Subject: **Docket Nos. 50-361 and 50-362**
Response to Request for Additional Information
NRC Generic Letter 2004-02
San Onofre Nuclear Generating Station, Units 2 and 3

Enclosure 1: Generic Letter 2004-02 Supplemental Response, Request for Additional Information

Enclosure 1
Generic Letter 2004-02 Supplemental Response
Request For Additional Information
Southern California Edison (SCE)
San Onofre Nuclear Generating Station Units 2 and 3

Figure II-2. LDFG Damage Curve for Small Fine Debris

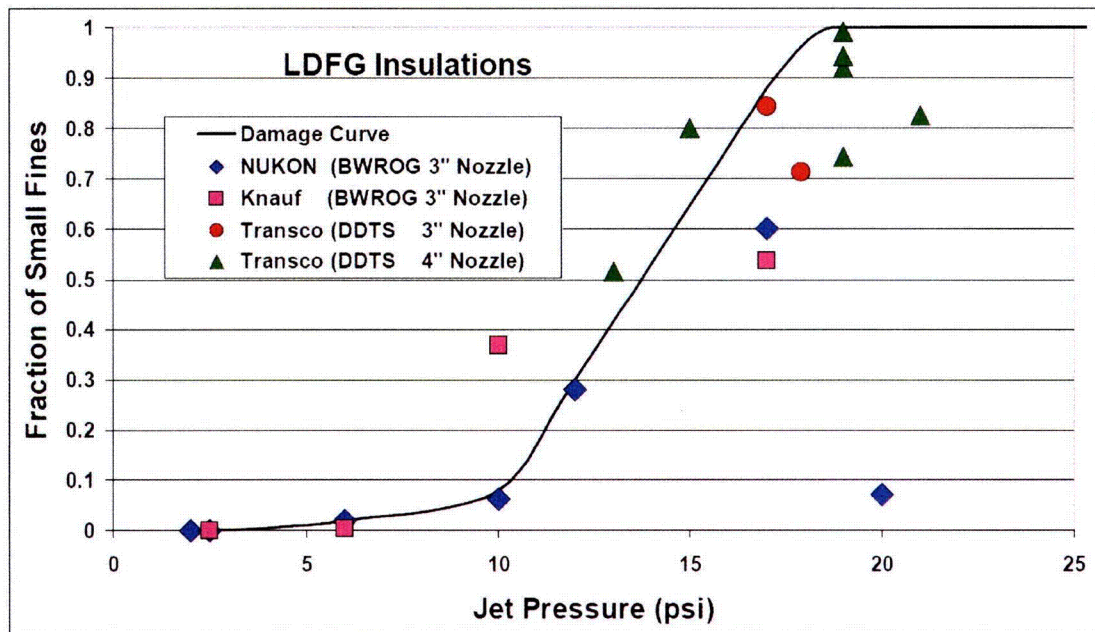
The licensee stated that additional justification for the 20 percent fines/80 percent small-piece size distribution has been included in Section 4.5.9.1 of the revised Alion Science and Technology Debris Generation Calculation. The NRC staff considers that the approach taken is inconsistent with the SE. The terms "fines" and "small pieces" in the Alion calculation are sub-sets of the term "small fines" as defined by the SE; all of the insulation debris generated is considered to be "small fines" as defined by the SE. Testing conducted for NUREG/CR-6369, "Drywell debris Transport Study" (ADAMS Accession nos. ML003726871, ML00328226, and ML03728322), with a zone of influence (ZOI) of 8D indicated a 20 percent fine fiber debris generation fraction. A 4D ZOI would be expected to generate a significantly higher proportion of fine fiber. The amount of fine fiber is significant from a head loss testing perspective. Please provide detailed

information which justifies the assumed size distribution of 20 percent fines and 80 percent small pieces for the 4D mineral wool ZOI.

The 7D ZOI sub-zone in the Alion size distribution methodology [Ref. 8.4] is based on the data shown in Figure II-2 of the SER [Ref. 8.2], and reproduced below. Note that the term "small fines" shown in the figure as defined in the SER is made up of both "fines" and "small pieces" of fiberglass debris. Note that Alion's calculations do not use the "small fines" designation, but instead use the "fines" and "small pieces" designation.

The curve that is fit through the data shows that 100% of the insulation debris generated is destroyed as “small fines” for destruction pressures greater than or equal to approximately 18.6 psi, which is equivalent to a 7.0D sphere [Ref. 8.4]. Note, however, that the limited air jet data points at pressures higher than 18.6 psi indicate that a significantly lower fraction of “small fines” could be generated at locations very close to the break. Or in other words, the “small fines” destruction curve may peak with maximum destruction at around 18.6 psi, and at higher pressures drop off to lower fractions of generated “small fines”.

In the Alion size distribution methodology, however, no credit is taken for reduced “small fines” destruction fractions at higher pressures. Instead, it was very conservatively assumed that 100% of the insulation inside 7D would be generated as “small fines” whether the insulation is located at 7D, 4D, or 1D.

Therefore, the size distribution used for the SONGS mineral wool is consistent with the guidance in the SER since 100% of the insulation within the 4D ZOI was conservatively assumed to fail as “small fines”, and was further broken down to 20% fines and 80% small pieces.

Figure 1 - Vertical Test Loop Apparatus

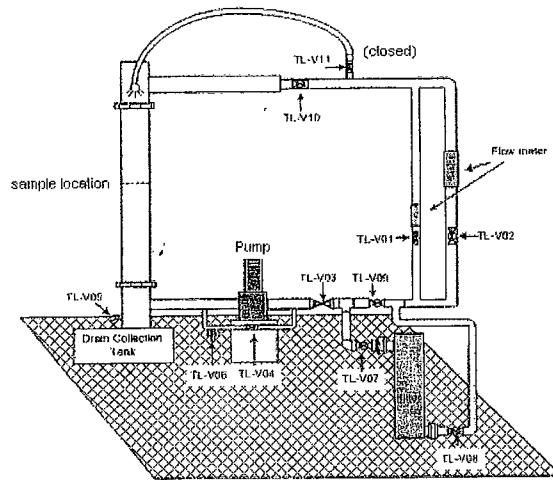
Audit open item number 6 stated that no justification had been provided for the assumption that containment spray drainage enters the pool as a dispersed flow rather than in concentrated streams. The open item noted that this could affect transport and the assumption of 10 percent erosion of small and large pieces of fibrous debris. The response to this item may have been partially acceptable in that the transport evaluation was revised to include a larger fraction of debris transported to the sump and a revision to the transport calculation. However, certain technical information, such as the magnitude of the change and the basis for the magnitude were not provided. In addition, the response noted that testing had been done to justify the assumption of 10 percent erosion of fibrous debris. Please provide the information that justifies the 10 percent erosion assumption. Also, please provide the information regarding the change in transport fractions due to the change in spray flow, including the basis for the change in transport.

The erosion tests were conducted both in Alion's Vertical Test Loop (VTL) and Flume as described in Figures 1 and 2. The VTL consists of a closed loop with flow circulated through the loop approaching the sample location from above. The fibers eroded off the samples are captured in the filter located downstream of valve TL-V07. The fiberglass small pieces are supported on a perforated plate at the sample location as flow passes through the samples.
